Our Ref: PR115598
Date: 25 September 2013

**RE: 120 – 128 HERRING ROAD, MACQUARIE PARK
MP09_0195 S75W MODIFICATION 4**

**Attachment A - Updated Urban Form Control Diagram
(Rev M) and Updated Urban Form Control Diagram
Elevation Along Herring Road (Rev J)**

**Re: S75W proposal Building E at 120-128 Herring Road,
Macquarie Park – Arboricultural Advice.**

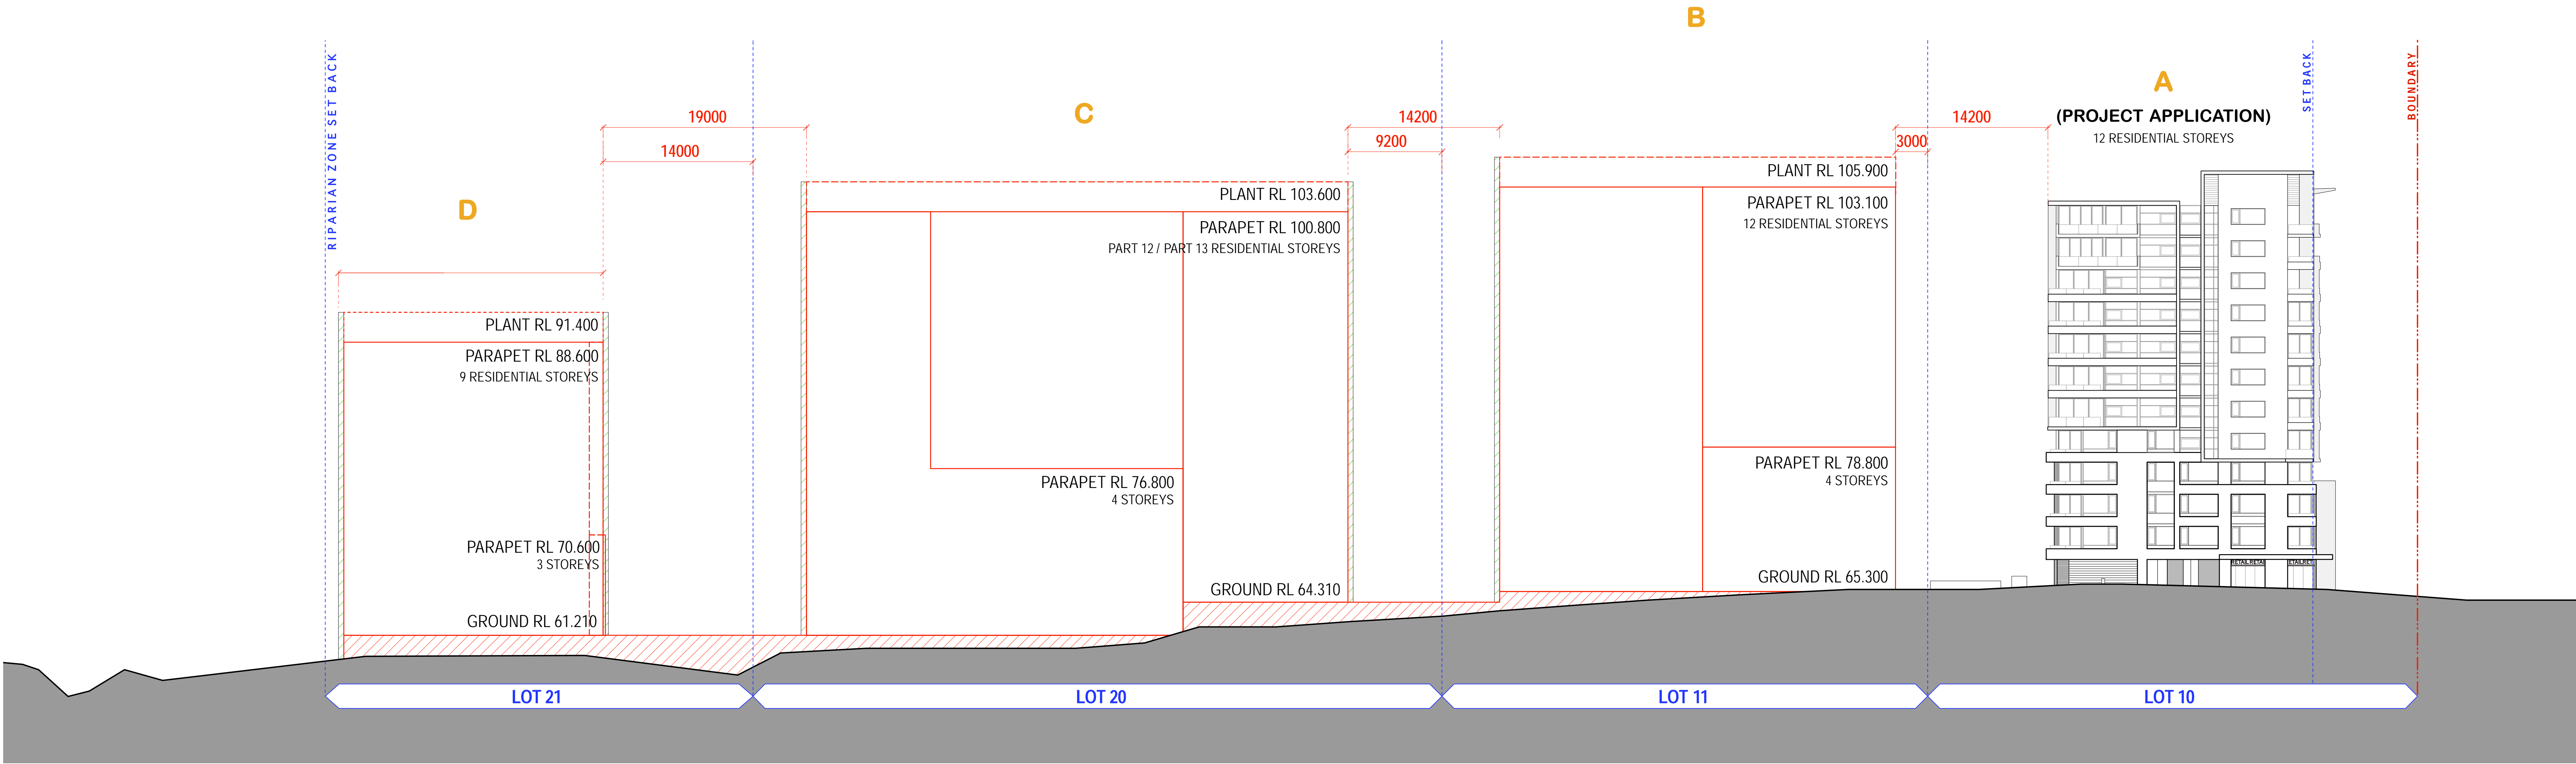
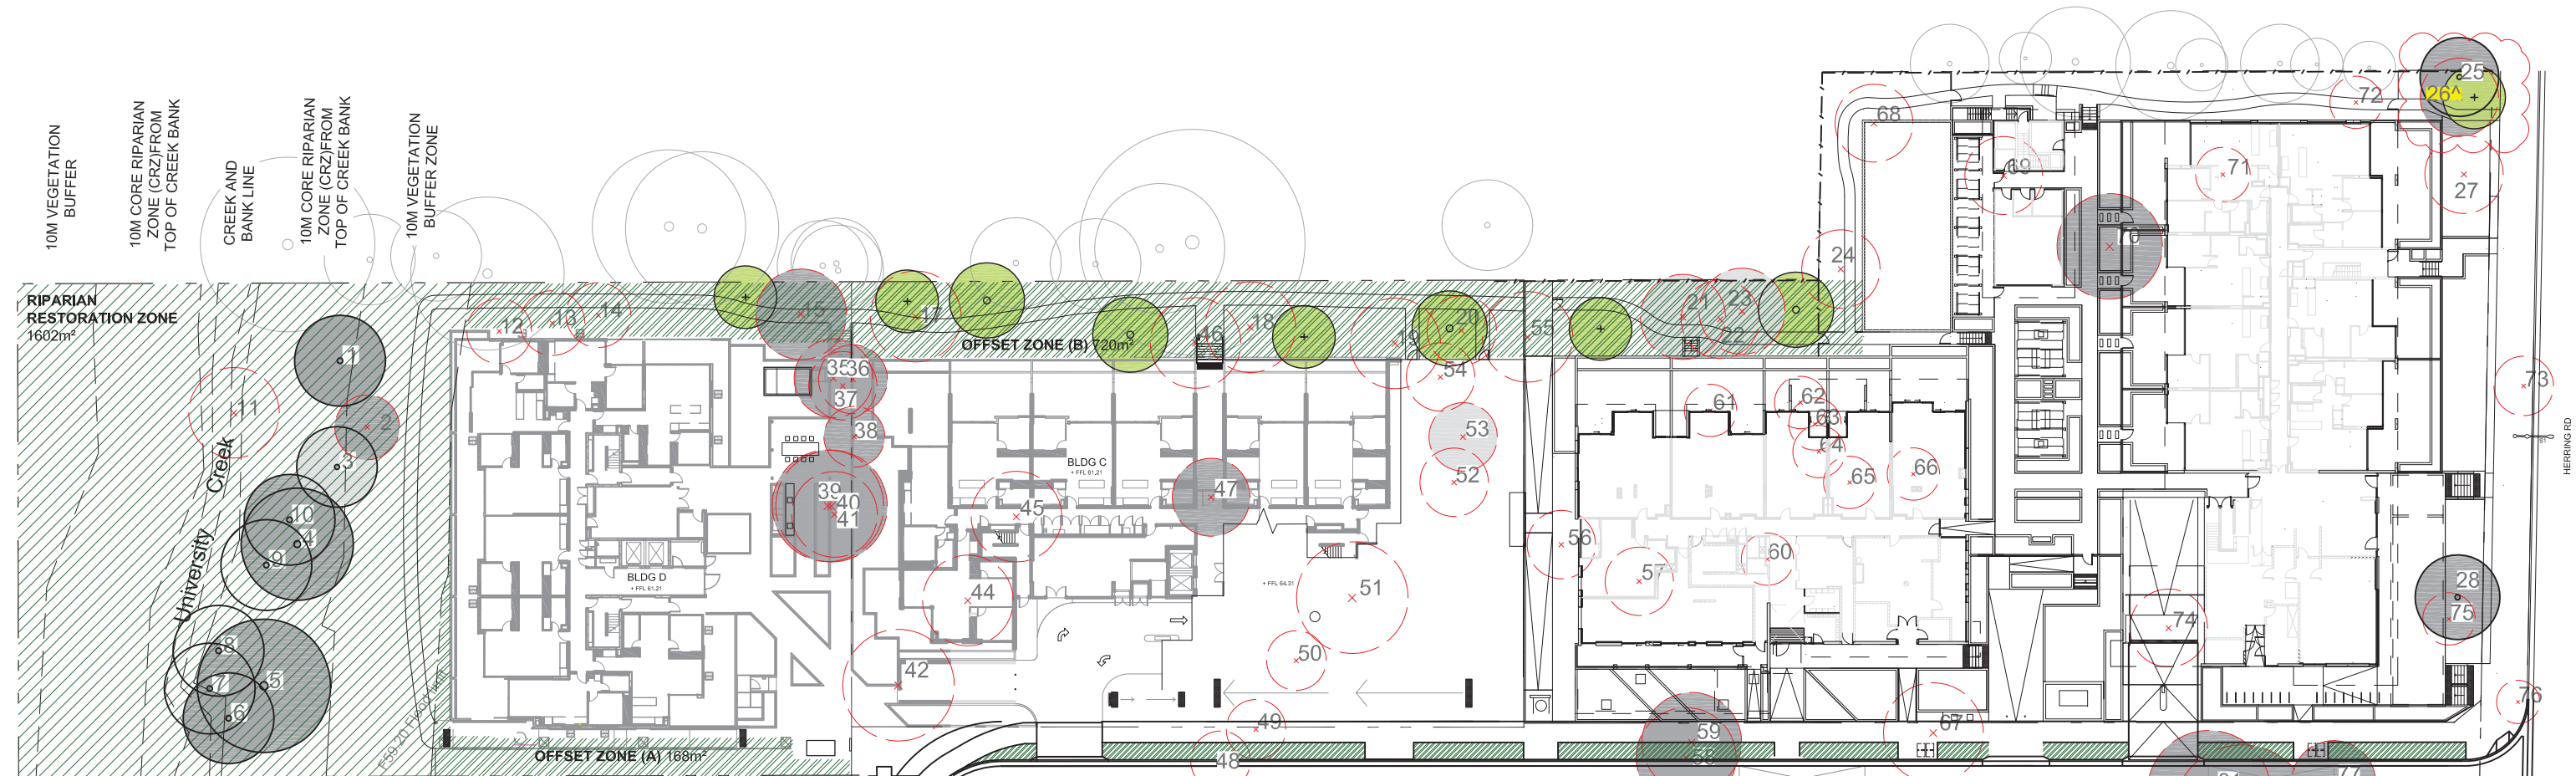
- Condition A2 - Replacement of drawing A161 Urban Form Control Diagram Rev L with Rev M at **Attachment A**.
- Condition A2 - Replacement of drawing A162 Urban Form Control Diagram Elevation Along Herring Road Rev I with Revision J at **Attachment A**.
- Condition A2 - Replacement of drawing LP-3 Tree Management Plan Rev E with Rev I at **Attachment B**.

The increase in the ground level of the lobby entry level/car park level will change the levels of Building E as follows:

Level description	Current level (RL)	Proposed level (RL)	Overall change (mm)
Lobby entry level / car park	65.60	66.10	500
Level 1	68.60	69.13	530
3 storeys from Lobby entry / car park parapet	76.10	76.29	190

The changes in the levels of Building E would not increase the overall height of the building. The consequential raising of all levels of the building by 500mm would be accommodated within redesigned roof space.

Figure 1 – TREE LOCATION AND IMPACTS PLAN

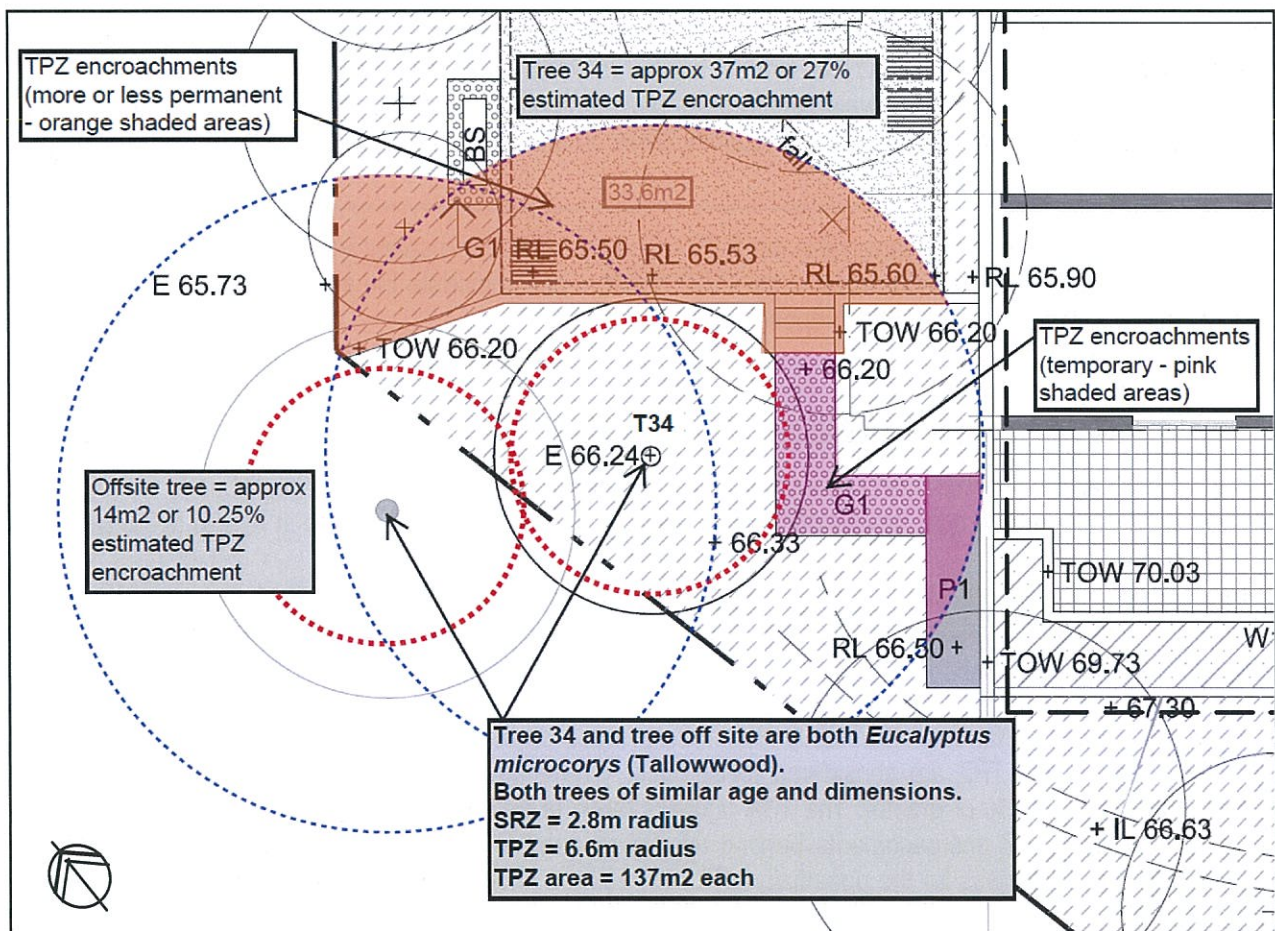
An estimated 27% of the total 137m² TPZ area of Tree 34 would be affected by proposed works. This equates to a high level of impact which may affect tree vigour and long term retention, and includes a very small potential SRZ encroachment which could affect tree stability if any woody roots present must be cut to accommodate the stairs to the lower lawn level (detention area).

However, there is likely to be potential for minor shifting of the stairs to avoid woody roots if they are present. It is possible the stairs could even be moved further into the SRZ. This would have to be determined by careful hand digging prior to finalising the steps location.

Given that there is some doubt that this tree may tolerate the estimated encroachments and cumulative impacts of the development, the possibility Tree 34 may have to be removed needs to be considered.

To increase the success of tree retention strict adherence to the following recommendations must be adopted.

- Tree Protection Devices ("TPD") are to be in accordance with AS4970, Figure 2 on the following page and those attached at the end of this report. The TPD must be in place prior to any site works commencing, including clearing, demolition or grading.

- An Australian Qualification Framework Level 5 ("AQF5") arboriculturist is to inspect tree protection devices and provide written confirmation of compliance with the tree protection recommendations of this report.

- All works undertaken within 5m of the trees is to be supervised by an AQF5 arboriculturist.
- Routine monitoring during the works for signs of tree decline is necessary. If the tree is deemed by an AQF5 arboriculturist to be in irreversible decline the tree is to be removed and replaced with a suitable tree canopy species.

Figure 2 – TREE PROTECTION PLAN

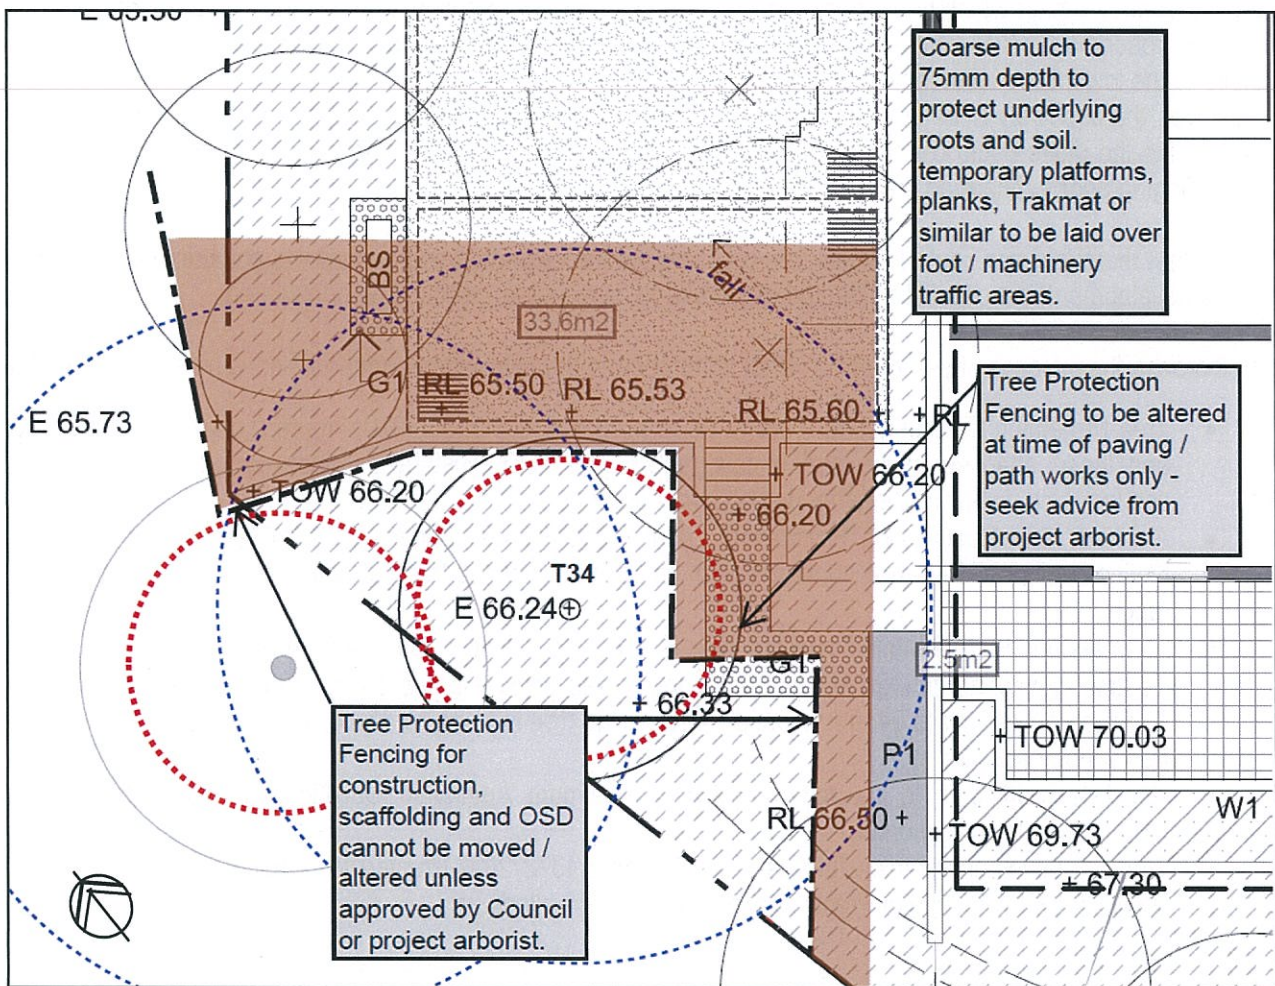
Drawing showing the recommended locations for protection fencing to EXCLUDE construction activities.
Landscape General Arrangements Plan L-001, cropped and marked up by C. Mackenzie.
